# THE RETREAT AT WOLF CREEK CONDOMINIUMS

## CONSTRUCTION DOCUMENTS EDEN, WEBER , UTAH

THE RETREAT AT WOLF CREEK CONDOMINIUMS  
CONSTRUCTION DOCUMENTS

POND OUTLET DETAILS  
 THE RETREAT AT WOLF CREEK CONDOMINIUMS  
 RETREAT DR  
 EDEN, WEBER, UTAH

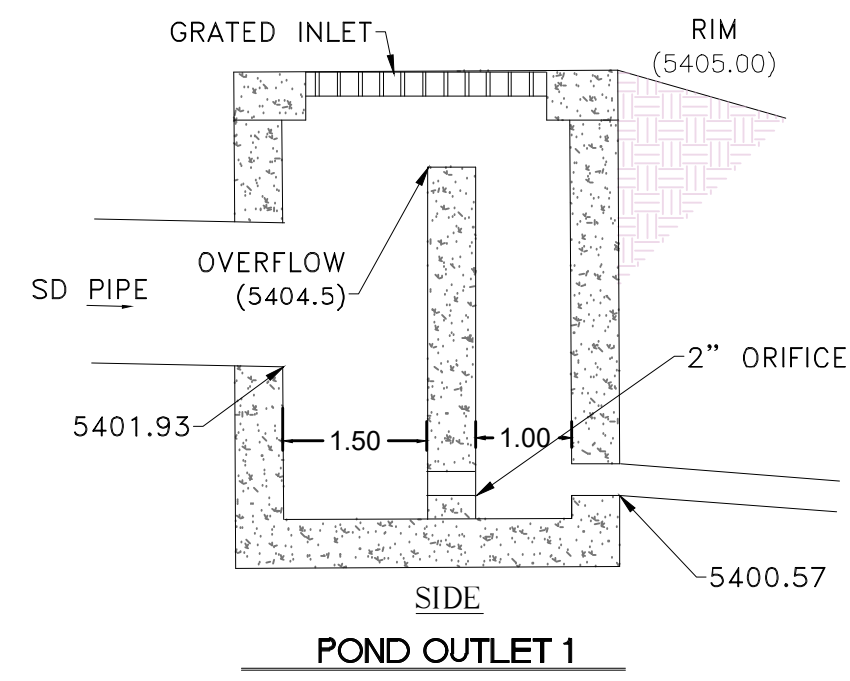
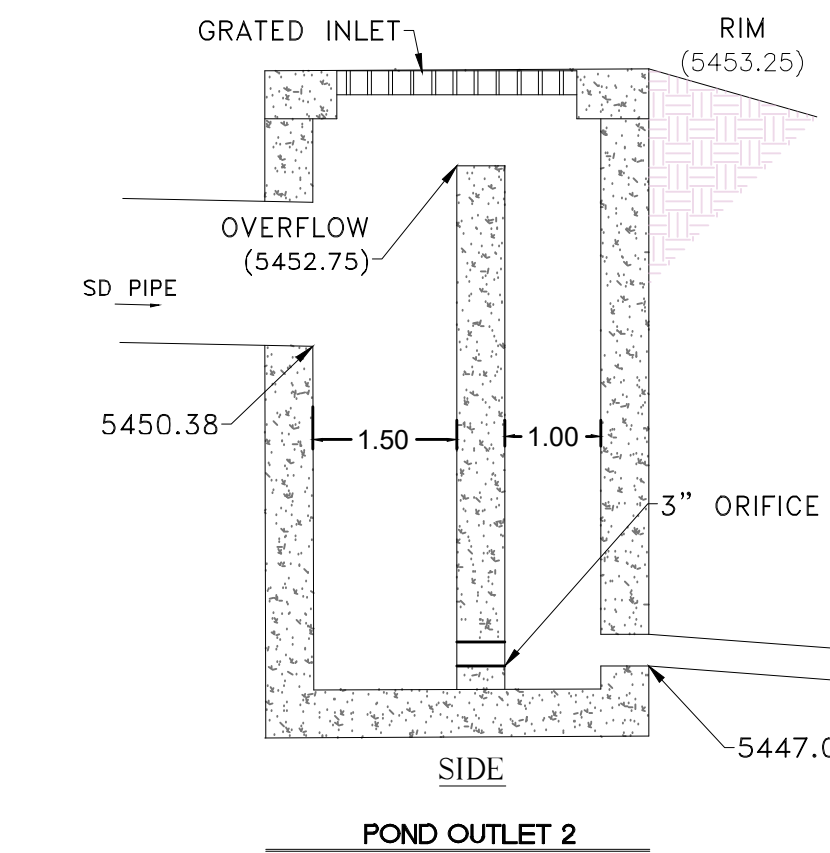
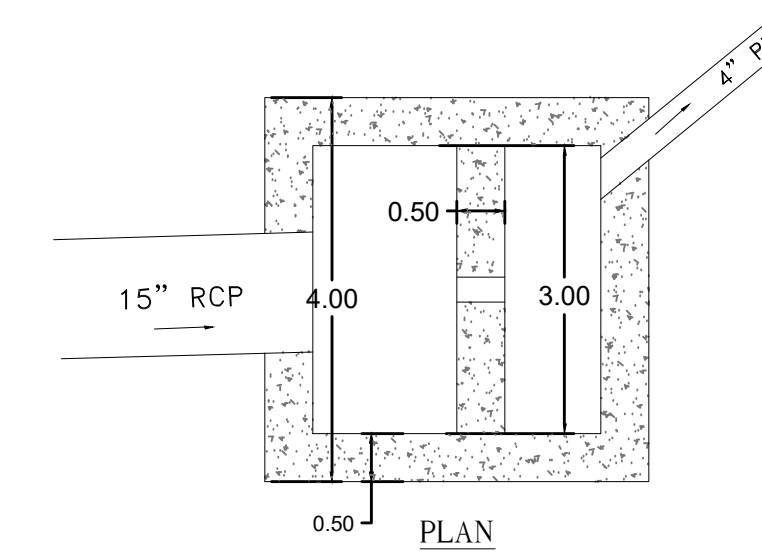
Can we get a bigger size of pipe for the outlet of both structures?
